Addendum No.: 3

Date of Addendum: June 2, 2020

Willard Diloreto Parking Garage
Paul Manafort Sr. Drive
New Britain, CT
CF – RC – 402

The following clarifications are applicable to drawings and specifications for the project referenced above.

1 SECTION AT DOUBLE TEE
S301 SCALE: 1/2" = 1'-0"

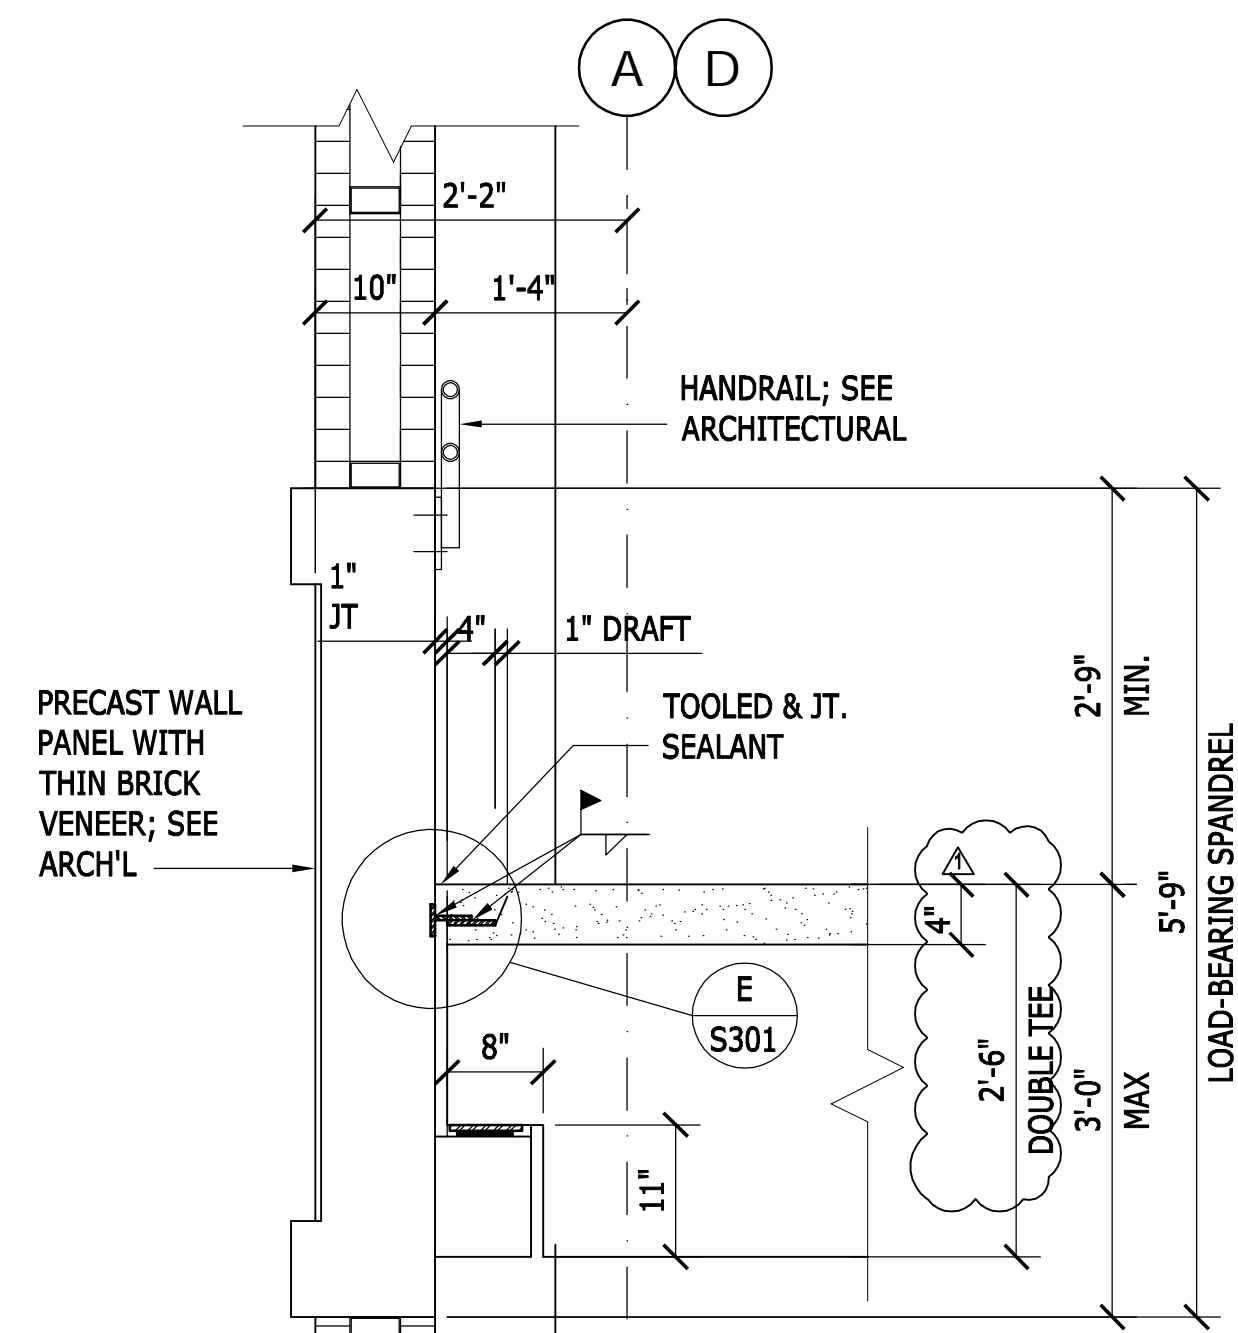
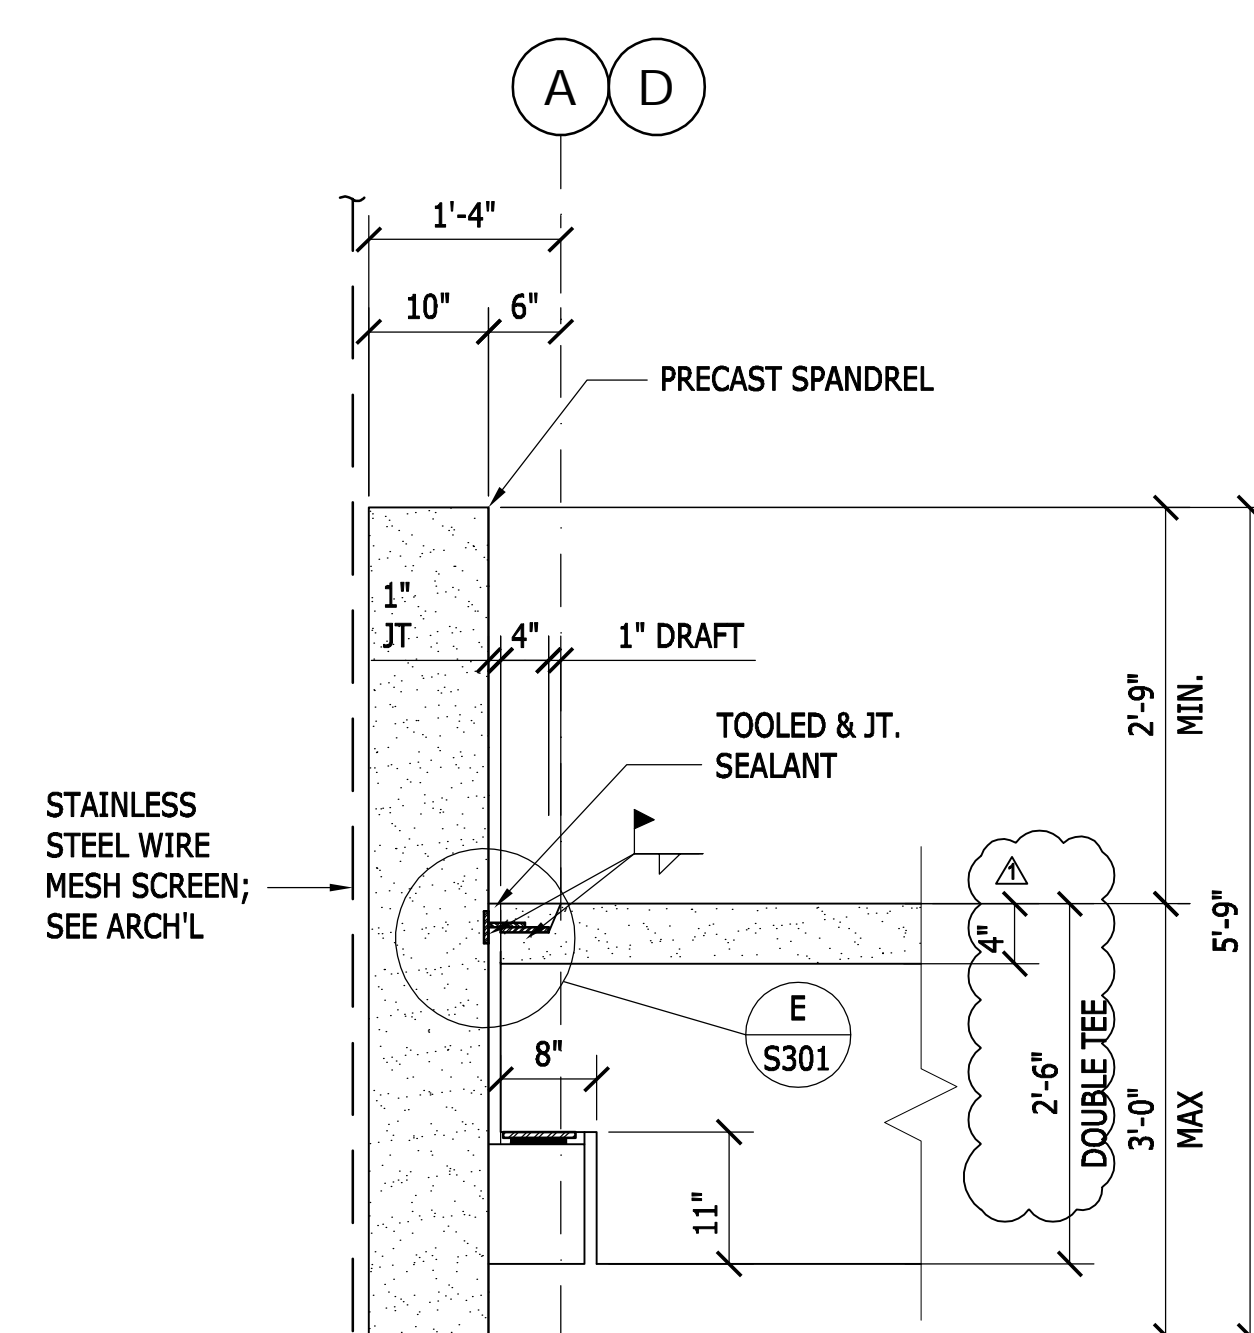
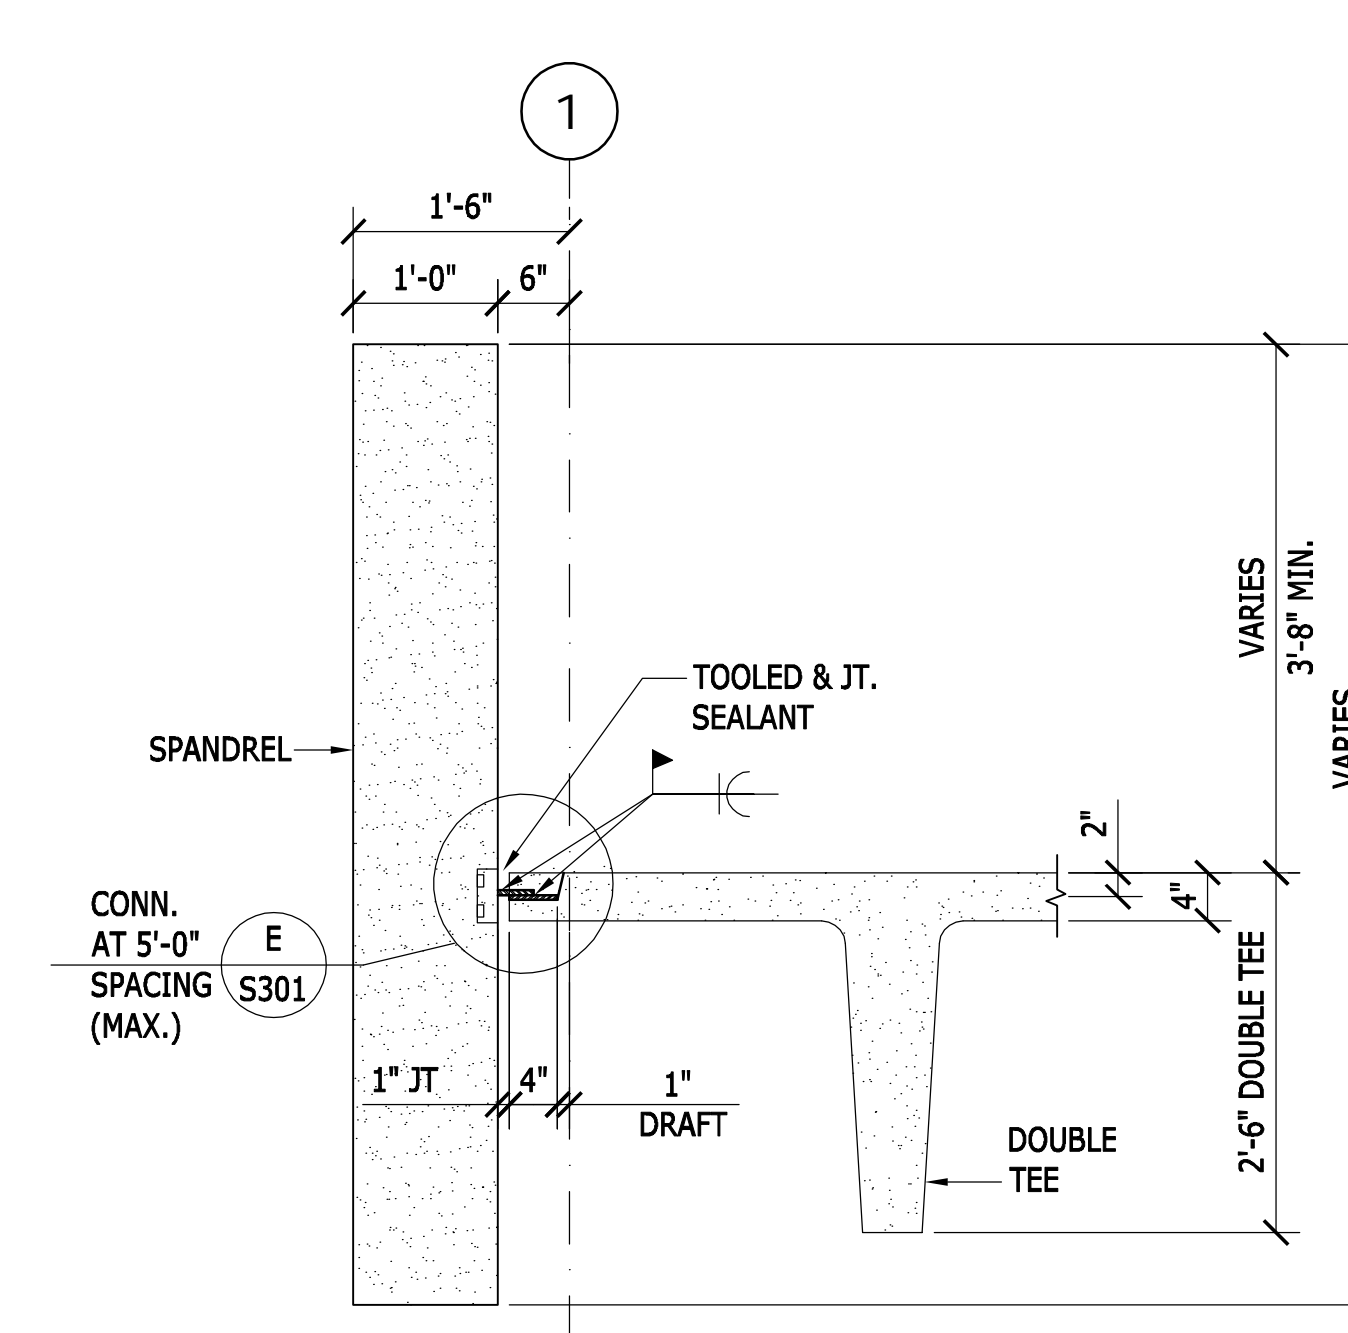
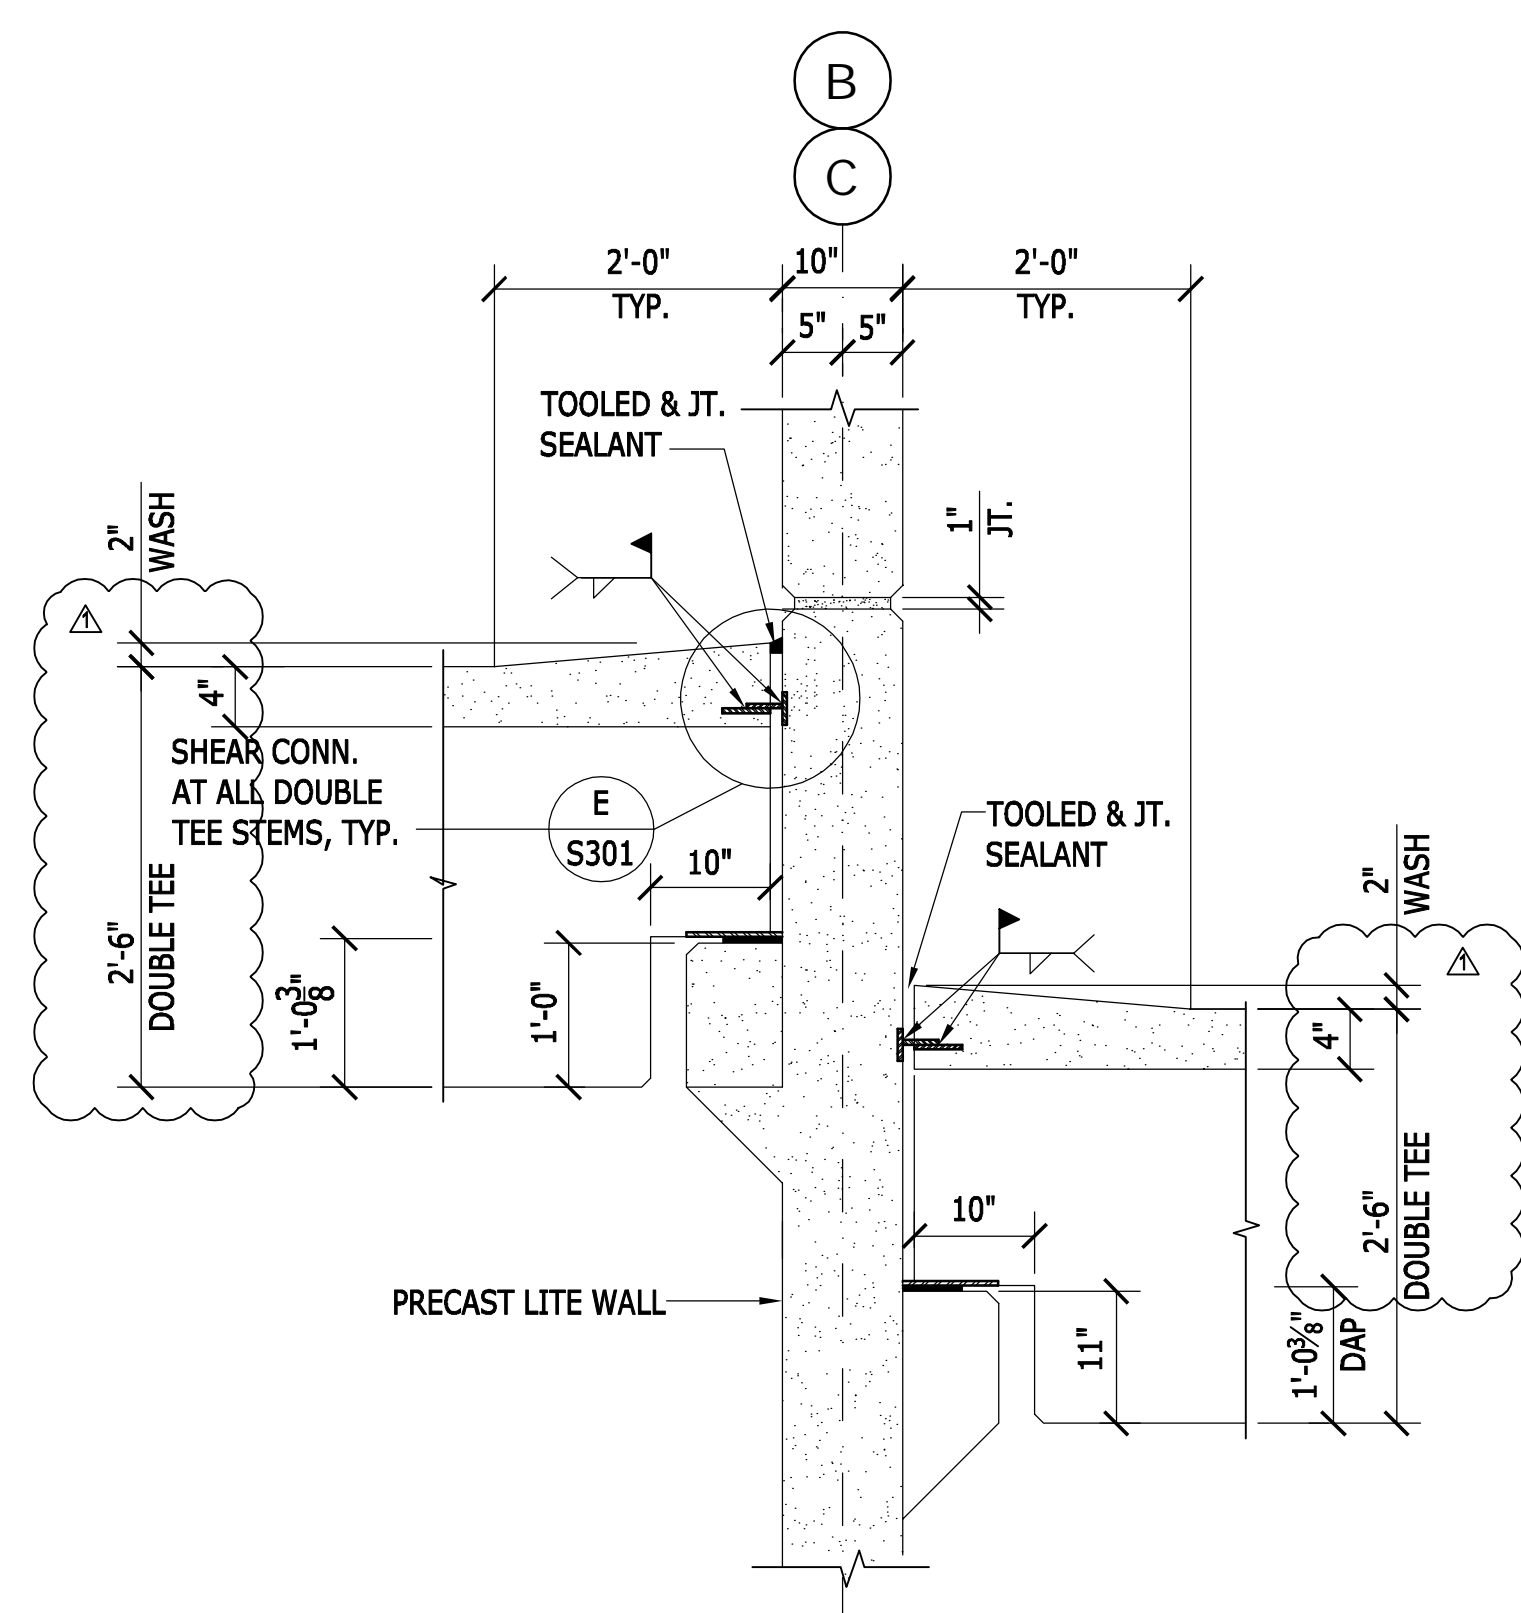
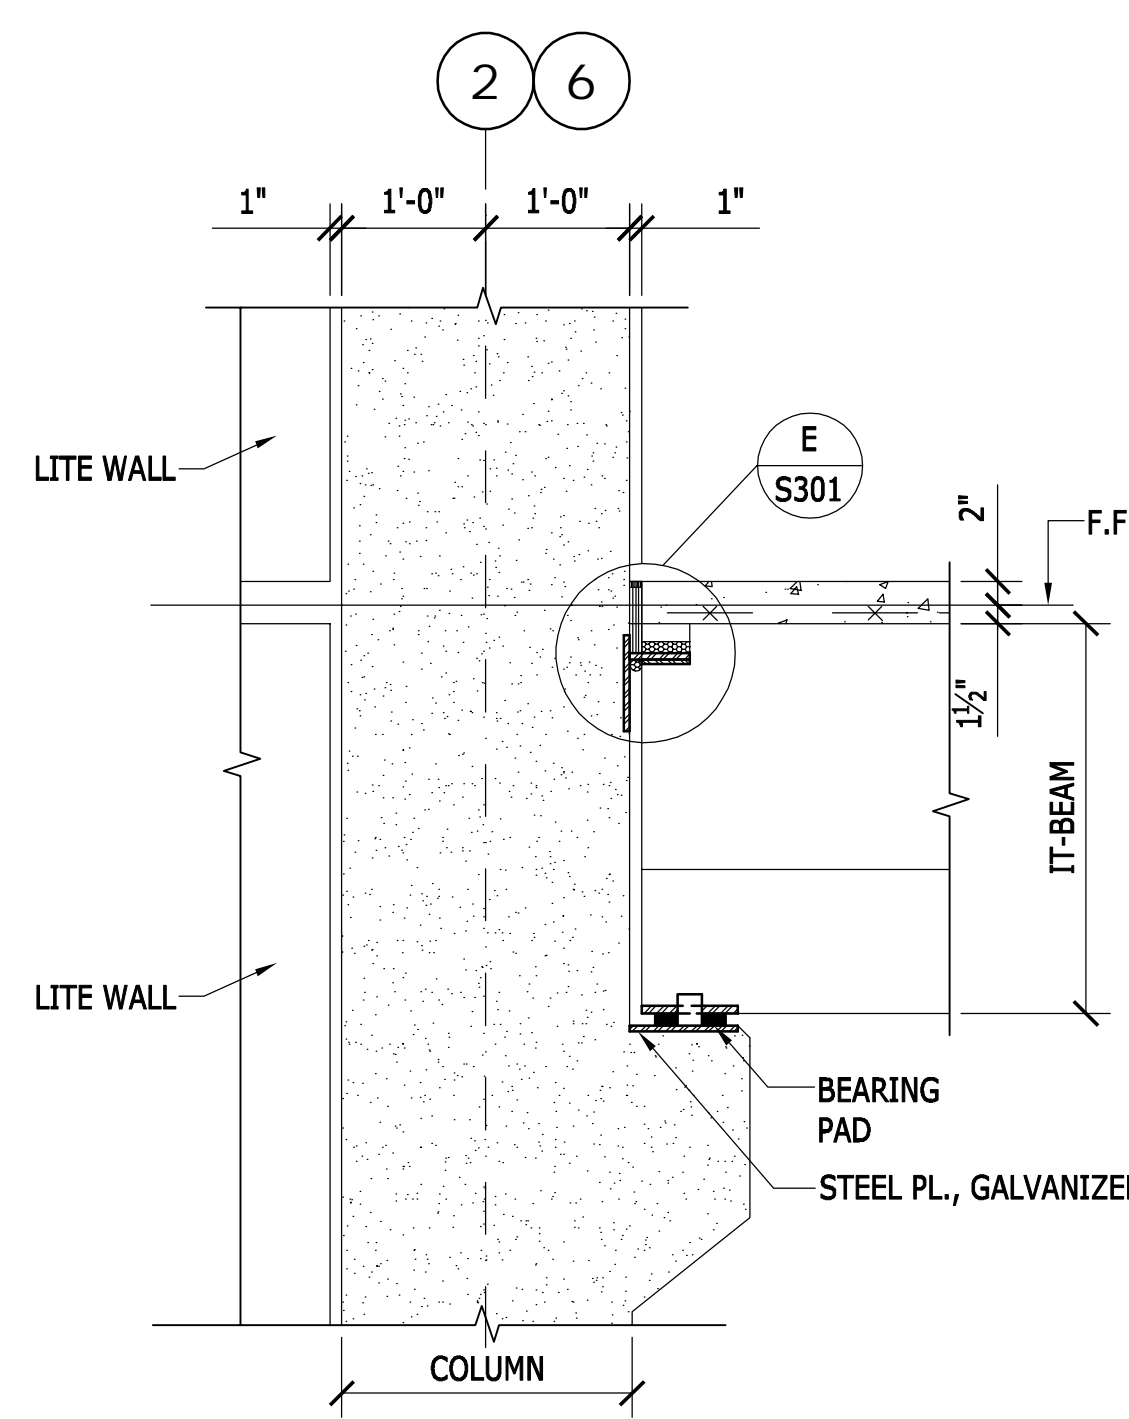
Question: Drawing S301 - Please advise if precast double tees are to be 2'-7" deep with 5" flanges as shown in Sections 1, 2, 3, and 5 or if they are to be 2'-6" deep with 4" flanges as shown in Section 4. Note: Details A, B, C, and D, indicate flange thickness of 4". Section 5 indicates litewalls along grids 'B' & 'C' as being 10" thick, whereas Sections 4 & 5 on drawing S105 indicate litewalls at 12" thick. Please provide the required thickness or advise if thickness is to be as determined by the precast design engineer. Section 1 – "Section at Double Tee" includes two (2) notes that are unclear. A note titled 'Additional Holes'. This note, as written, may be interpreted to mean that All Holes for MEP trades are to be provided as cast-in-sleeves, which is not the standard industry practice. Specification Section 034100 page 8 Paragraph 2.10 E. correctly describes that openings 10" square or round shown on the final precast shop drawings will be cast in, however smaller openings will be cut in the field by Trades requiring the openings. Please consider deleting or revising the note re: 'Additional Holes' to avoid confusion. The note that reads; "4" x 6" sleeve through stem, 3" max. per stem at 1/3 point from end and midspan", is unclear. Please clarify the number of 4" x 6" sleeves required at each Double Teestem.

Answer: See revised drawing S301. Details 1,2,3, and 5 have been revised to indicate 2'-6" deep double tees with 4" flanges. The "Additional Holes" note on detail 1 has been eliminated. The notes regarding sleeves through the stems have been revised to indicate two (2) 4" x 6" sleeves through each stem at third points of the span.

2 STAIR SECTIONS
S303 SCALE: 1/2" = 1'-0"

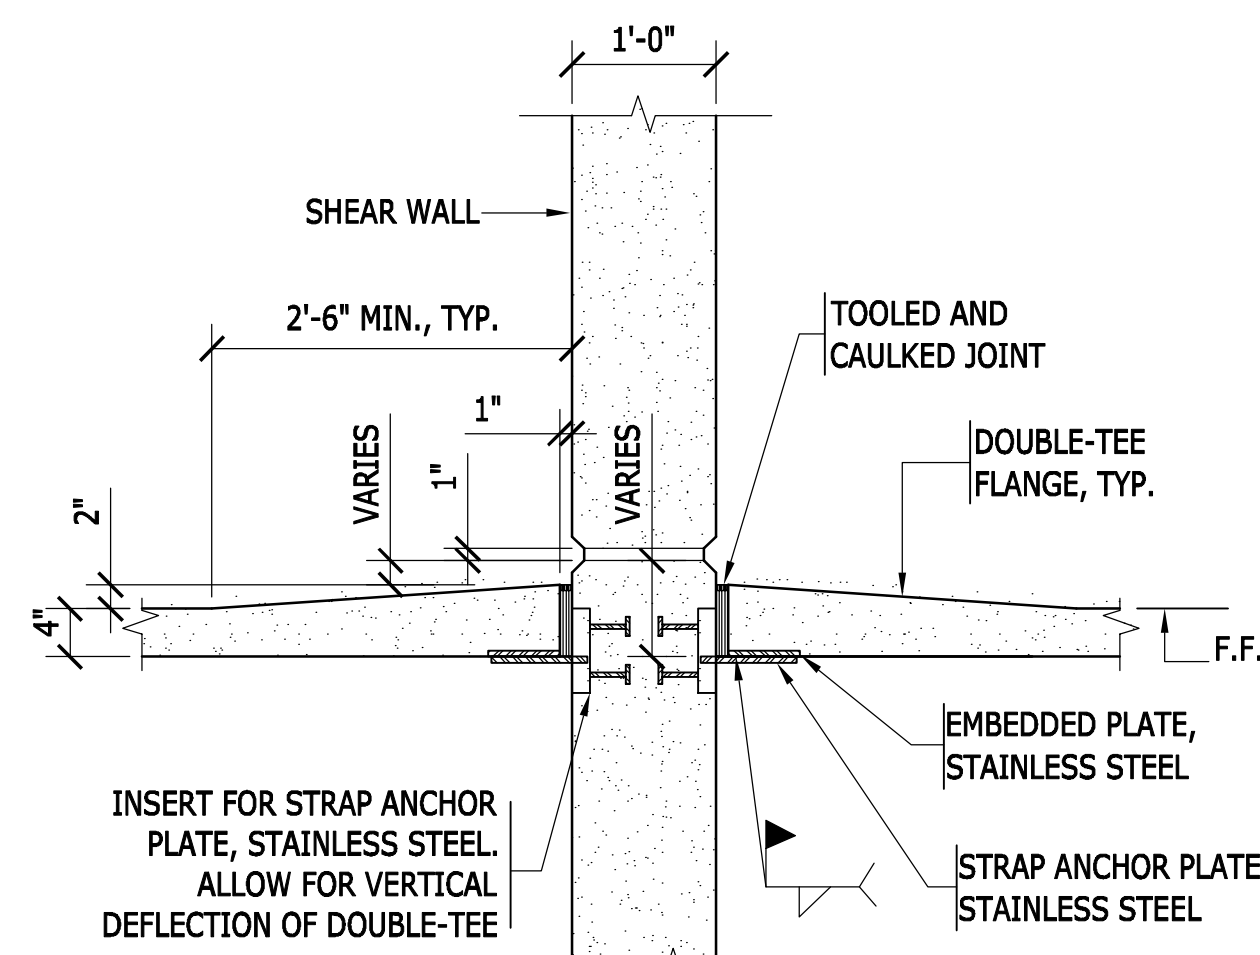
Question: Drawing S303 - Stair Section 2 indicates precast double tee depth of 2'-10". Please advise if any 2'-10" deep precast tees are applicable to this project.

Answer: See revised drawing S303. The double tee depth in Stair Section 2 has been revised to 2'-6".
